# ETON America, LLC

Bulletin No.: **SB-0059**

## E-TON 40cc Carburetor update

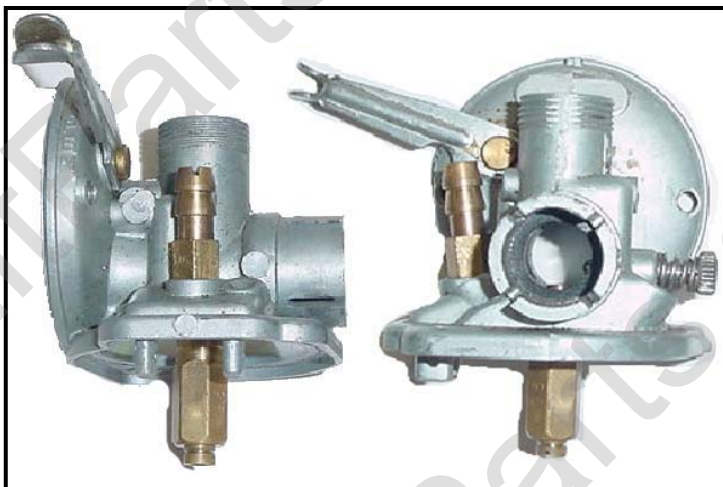
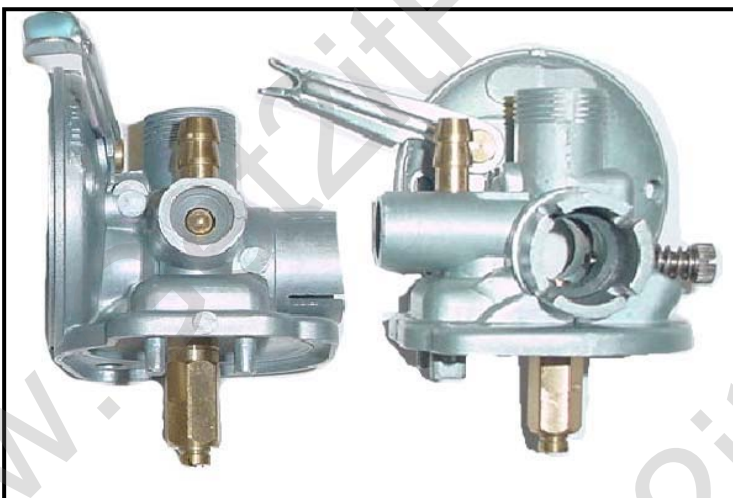
Old style Carburetor **does not** require replacing the inlet pipe.

NEW style Carburetor **DOES** require replacing the inlet pipe.

The New Designed carburetor supplied on engine numbers ending with 010772 and greater.

Engine numbers ending with a number lower than 010772 **REQUIRE** Replacing this part before installing the new style carburetor.
